Access Compliance Report

Public Rights-of-Way

Intersection ID: 29111	Main Street: ARBOR_SPRING_DR	Cross Street: HERON_GLEN_DR	Location: S
ADA ID: 13DC0345622A	Ramp Type: BlendTrans1	Initial Pass/Fail: Pass	Overall Compliance: No
			Severity Score: 14.25

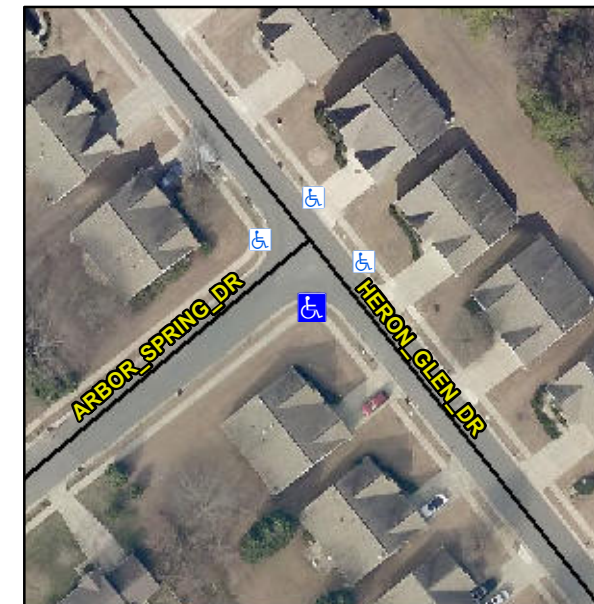
R304.5.3, R304.2.1, R305

Compliance	Description	Data	Compliance	Description	Data
N/A	Ramp Length (in)	47.0	Yes	BlendTrans Slope (%)	3.8
Yes	Ramp Width (in)	48.0	No	BlendTrans XSlope (%)	2.6
N/A	Flare Type LT	Sloped	N/A	Flare Type RT	Sloped
N/A	Flare Slope LT (%)	5.5	N/A	Flare Slope RT (%)	0.9
N/A	Flare Traversable LT?	No	N/A	Flare Traversable RT?	No
No	Landing Length (in)	47.0	No	DWS Provided?	No
No	Landing Width (in)	40.0	N/A	DWS Contrast?	No
Yes	Landing Slope (%)	1.0	N/A	DWS Length (in)	N/A
Yes	Landing X Slope (%)	1.6	N/A	DWS Full Width?	No
N/A	Landing Curb? (Y/N)	No	N/A	DWS Offset (in)	N/A
N/A	Shared Landing?	No			
Yes	Gutter Ponding?	No	Yes	Gutter Slope (%)	2.5
Yes	Gutter Lip Ht (in)	0.0	Yes	Gutter X Slope (%)	1.7
N/A	Painted X Walk1?	No	N/A	Painted X Walk2?	No
	X Walk 1 Direction	To NE		X Walk 2 Direction	To NW
	X Walk 1 Width (in)	N/A		X Walk 2 Width (in)	N/A
	X Walk 1 Slope (%)	3.6		X Walk 2 Slope (%)	3.5
	X Walk 1 X Slope (%)	2.9		X Walk 2 X Slope (%)	3.8

Remove & Replace Curb Ramp With Two New Directional Ramps or Equivalent.
